RENESAS TECHNICAL UPDATE

Product Category	MPU/MCU		Document No.	TN-SH7-A759A/E	Rev.	1.00
Title	SH7763 DDRIF electrical characteristics specifications change and errata		Information Category	Technical Notification		
Applicable Product	R5S77630Y-266BGV R5S77631Y266BGV R5S77632Y266BGV	Lot No.	Reference Document	SH7763 Hardware Manual (REJ09B0256-0200)		
		All lots

1. DDRIF Signal Timing specifications change (Table 43.12 DDRIF Signal Timing)

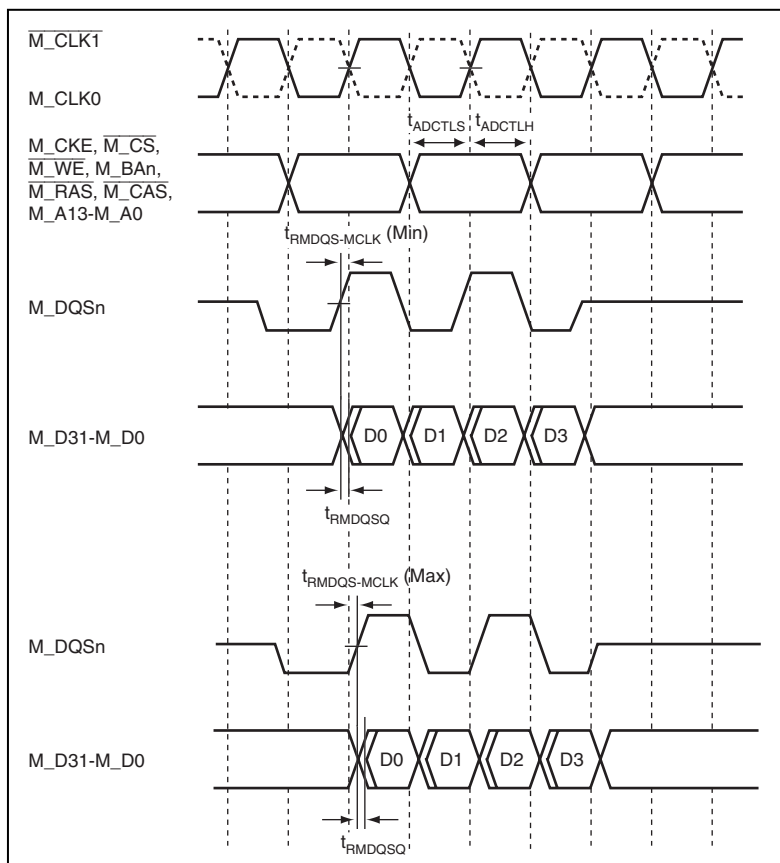
Before correction

Item	Symbol	Min.	Max.	Unit	Figure	Remarks
M_CLK-to-M_DQSn skew time (read)	$t_{\text{RMDQS-MCLK}}$	-1.0	1.0	ns	43.29	DDR200
		-0.8	0.8			DDR266

After correction

Item	Symbol	Min.	Max.	Unit	Figure	Remarks
M_CLK-to-M_DQSn skew time (read)	$t_{\text{RMDQS-MCLK}}$	<u>-0.75</u>	<u>1.82</u>	ns	43.29	DDR200
		<u>-0.35</u>	<u>1.23</u>			DDR266

2. DDRIF Signal Timing errata (Figure 43.29 Read Timing of DDR-SDRAM (2 Burst Read))

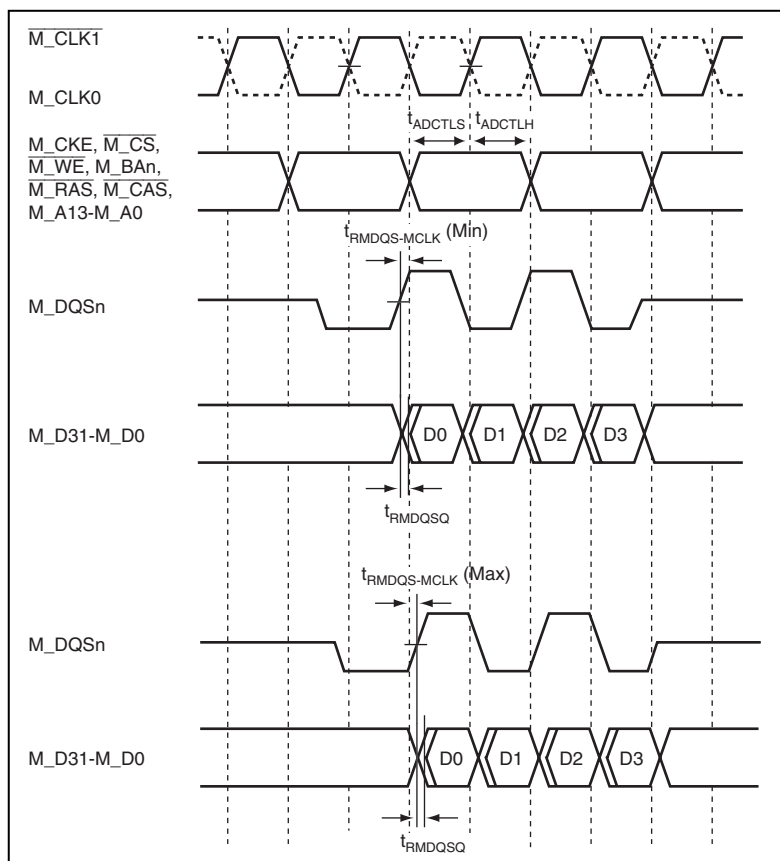
Before correction

After correction
